DATE: JUNE 04, 2004
TO: U.S. DISTRIBUTORS
**SUBJECT: RECALL R04HT INCORRECT FASTENERS IN DRIVER'S
3-POINT SEAT BELT UPPER ATTACHMENT**

3-Point Seat Belt Fasteners

MODELS AFFECTED: 2004 & 2005 A3FE with Option 2836-01, Driver's 3-Point Seat Belt

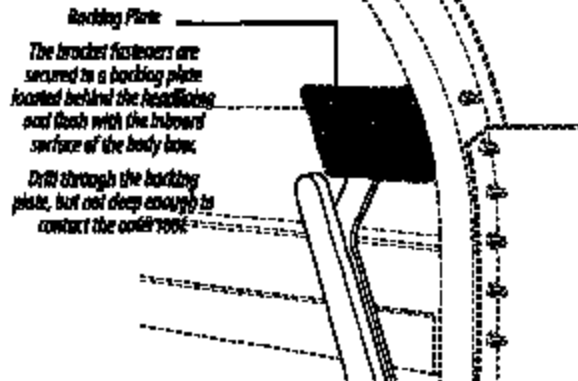
Remove two Torx fasteners to remove shoulder belt height adjuster in order to gain necessary clearance for installing Huck fasteners.

2 Remove the seat belt height adjuster bolts, using a T50 Star Bit Socket/Torx Head Bit socket.
